R/108/21/PL – Submission of Additional Information

Full planning application for the demolition of two dwellings and the construction of 3 No. 3-bed town houses and 7 flats. This site is in CIL Zone 4 and is CIL Liable as new dwellings at 117 Sea Lane Rustington BN16 2RU

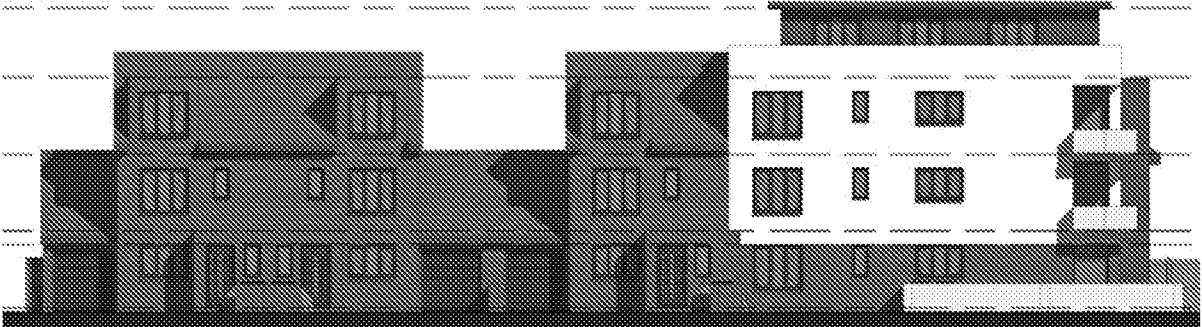
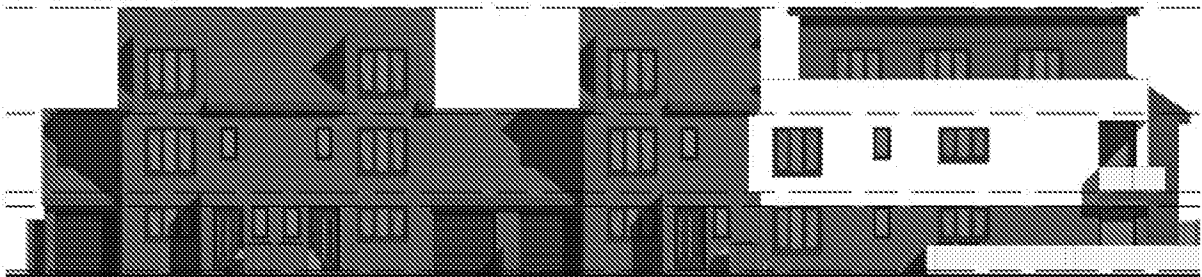
- 1. By virtue of its scale, bulk and height the development is considered to be out of character with the existing area and the absence of space around the development to provide sufficient landscaping will not mitigate this harm contrary to policies D DM1, D SP1 of the Arun Local Plan and policy 2 of the Rustington Neighbourhood Plan.*

Revised plans have now been submitted which reduces the quantum of development. The original submission proposed a four-storey block of 7 flats. The block of flats has now been revised to propose a three storey block of 5 flats. The revised elevation, as viewed from Shaftesbury Road is below.
